Village of Arlington Heights
Plan Commission
Board Room
Arlington Heights Village Hall
33 S. Arlington Heights Road
Arlington Heights, IL 60005
June 27, 2018
7:30 PM

- A. Hickory/Kensington - 4 N. Hickory Ave. - PC#18-005
Planned Unit Development, Preliminary Plat of Subdivision,
Variations
- B. Christian Liberty Subdivision - 502 W. Euclid Ave. - PC#18-011
Preliminary & Final Plat of Subdivision, Variations

RE: 1540 NORTH ARLINGTON HEIGHTS ROAD
PUD AMENDMENT-PC#18-007

PC1-1.1

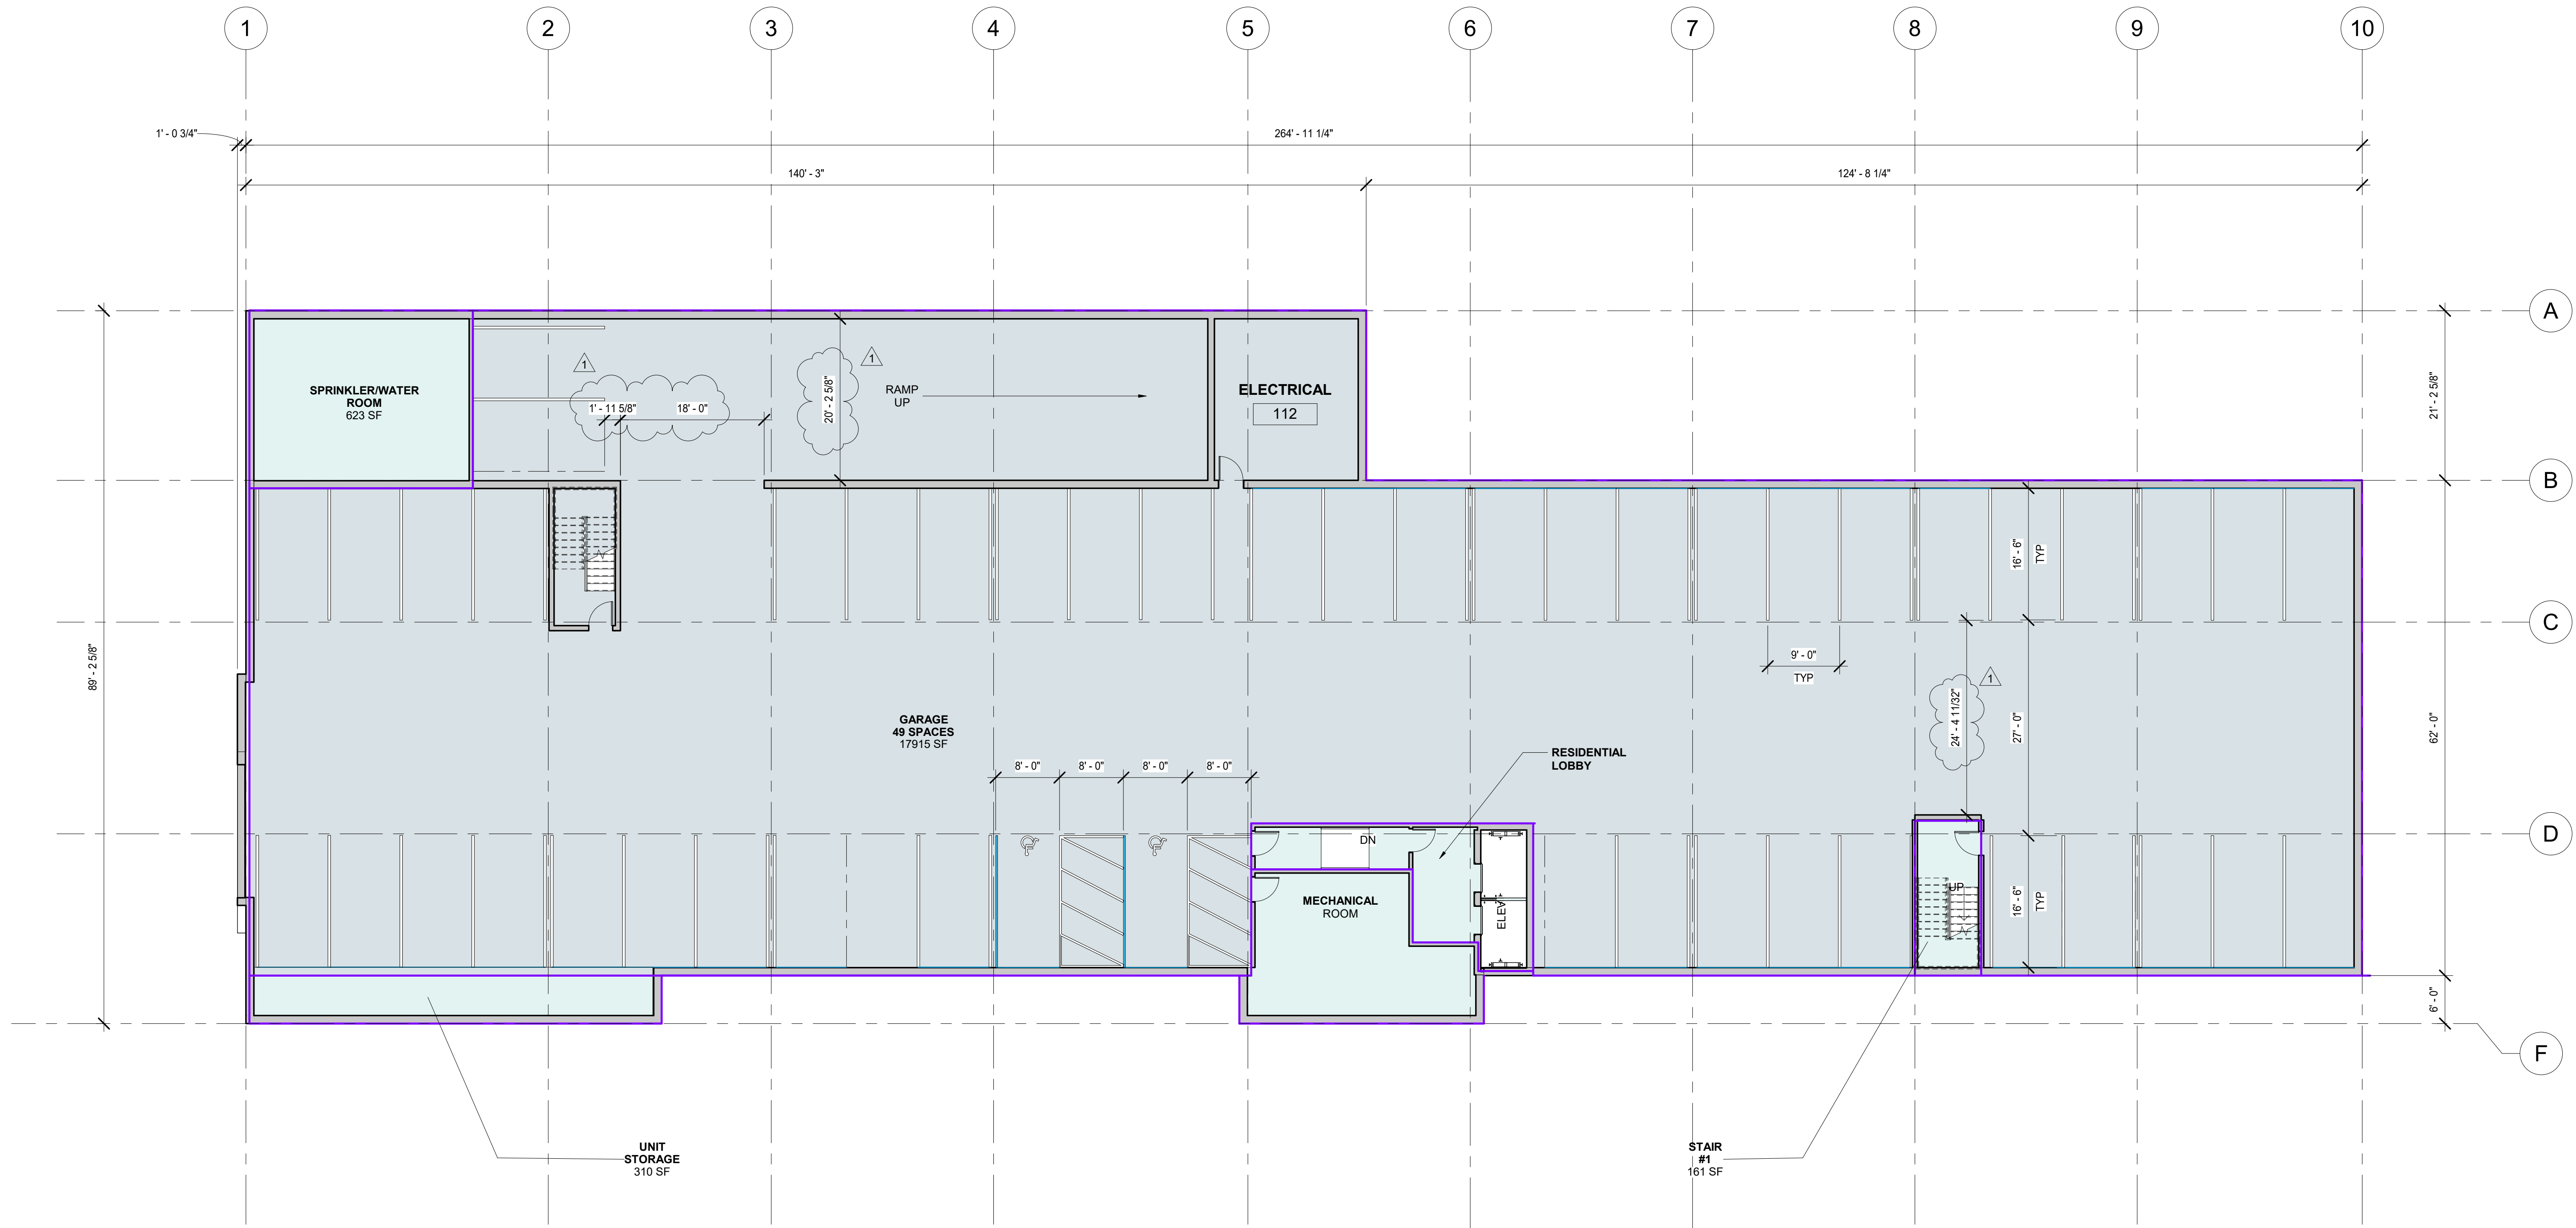
Area of exterior surface parking lot is 13,038.7 s.f. as noted on sheet PC1-1.1 and PC1-1.2

- Sheet PC1-1.1 and PC1-1.2 have been revised to show the location of the transformer
- COMMENT 19:** Overhead utilities along the north side Kensington between Hickory and Douglas must be buried as part of this development, unless the utility companies or the Village deems it not feasible. All cost associated with the utility burial shall be the developers responsibility. Please add a note to the engineering site plan indicating the location of the required utility burial

- Gas and electrical meters will be located along the west wall along the drive. See sheet PC1-1.1 and PC1-1.2.

SHEET NO.
PC6-1.0

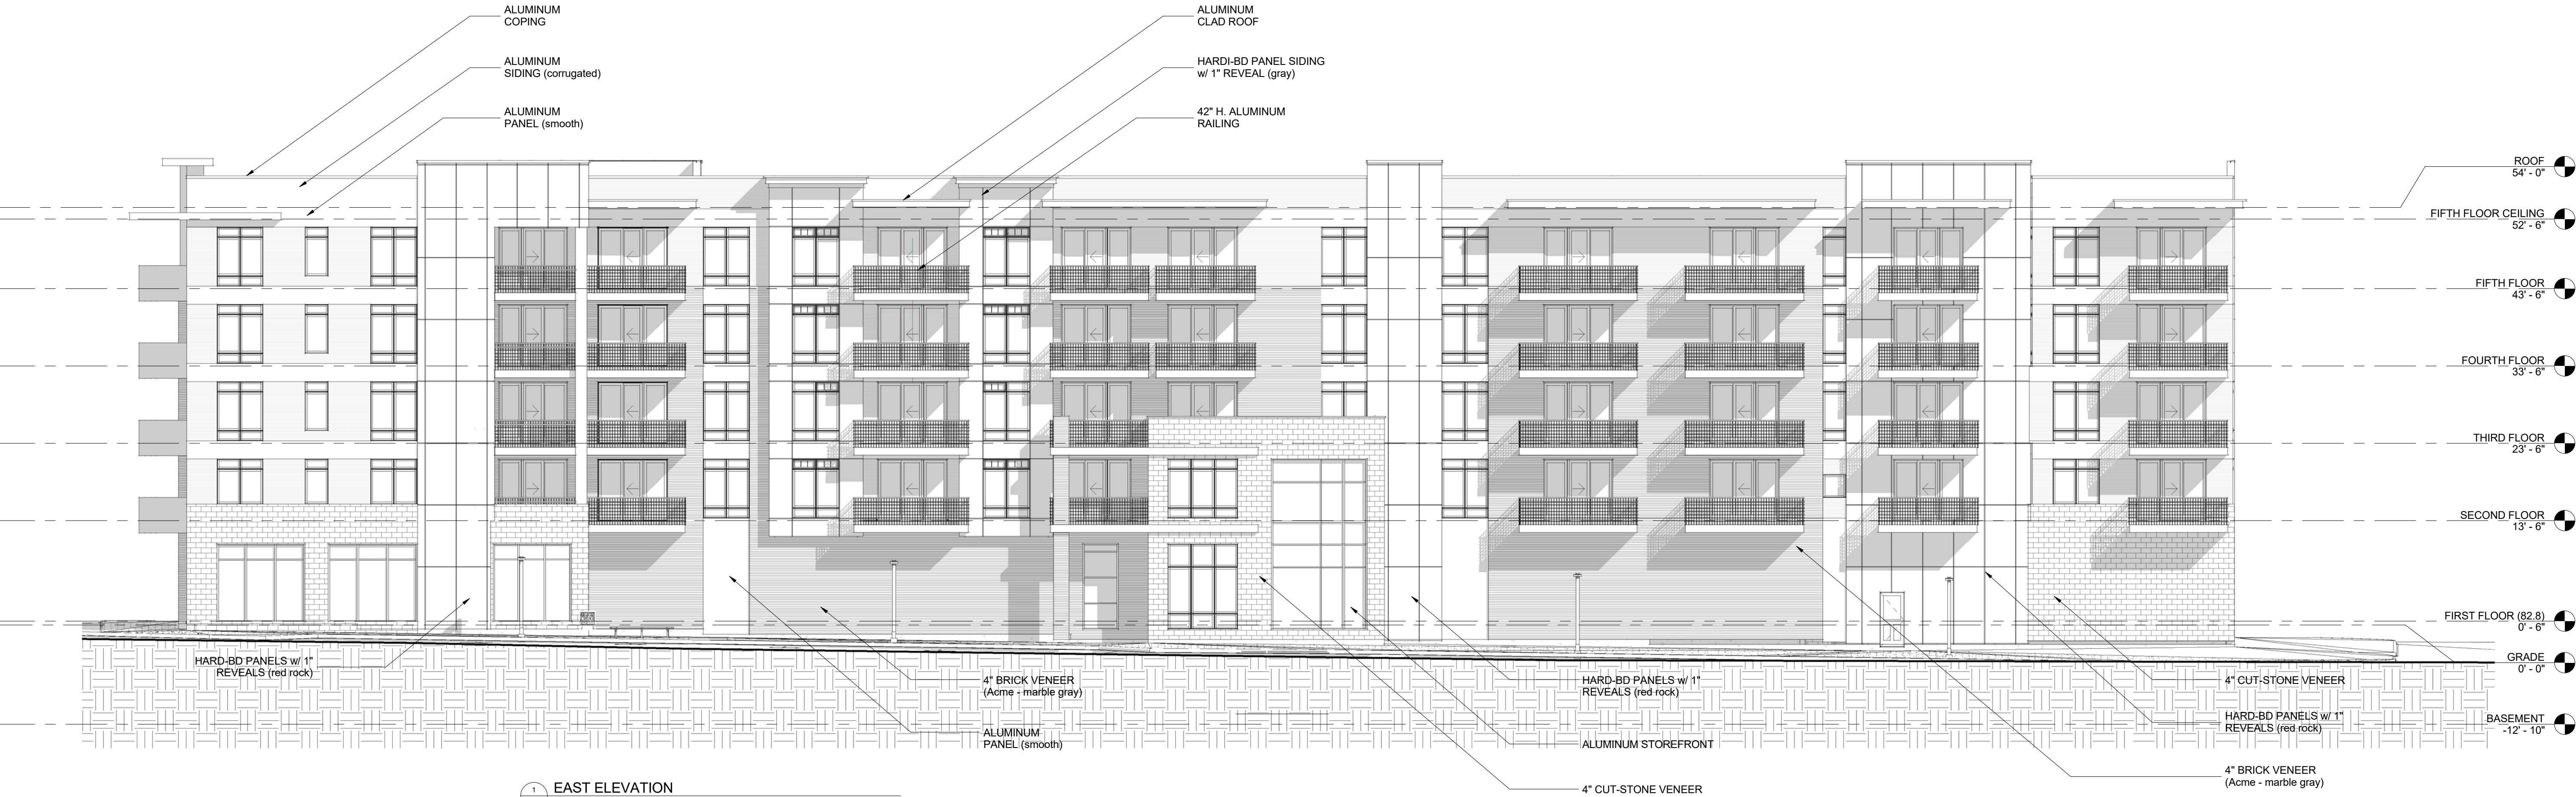
The 54' height is measured to the top of the roof. The section on sheet PC6-1.0 has been revised accordingly

TURNING EXHIBIT – FIRE TRUCK 3
KENSINGTON AND HICKORY DEVELOPMENT
ARLINGTON HEIGHTS, ILLINOIS

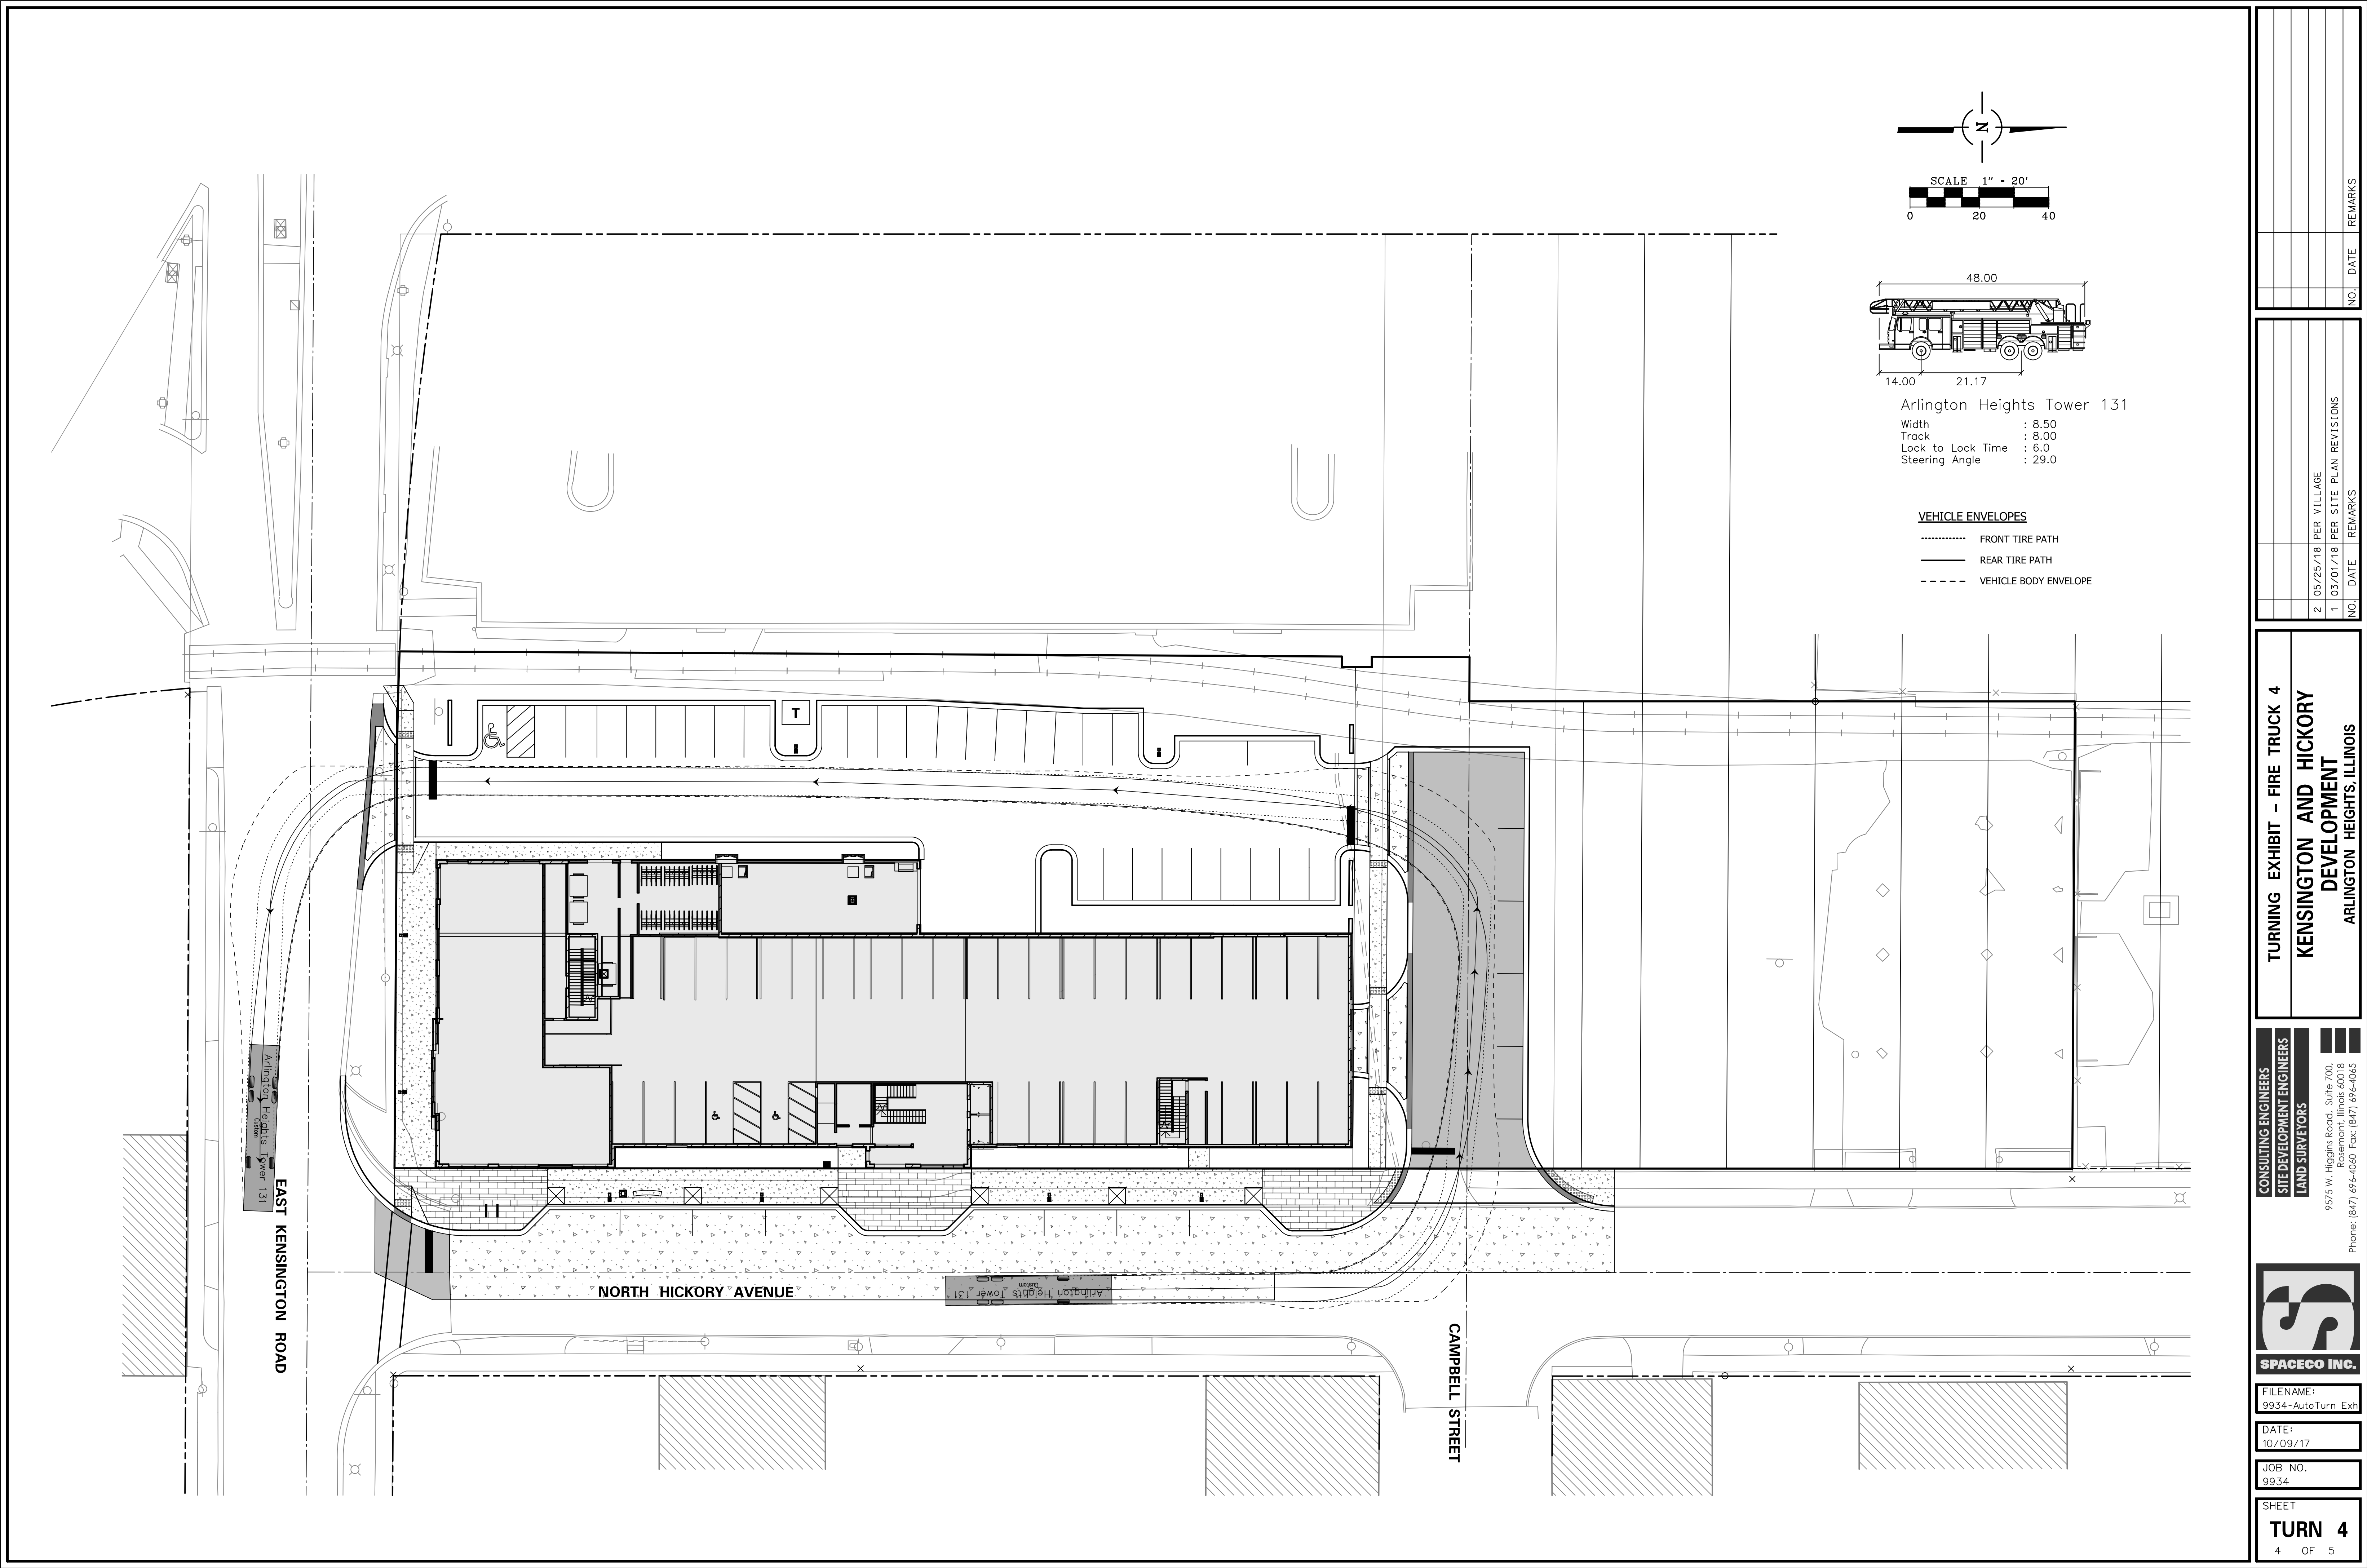
NO.	DATE	REMARKS
2	05/25/18	PER VILLAGE
1	03/01/18	PER SITE PLAN REVISIONS
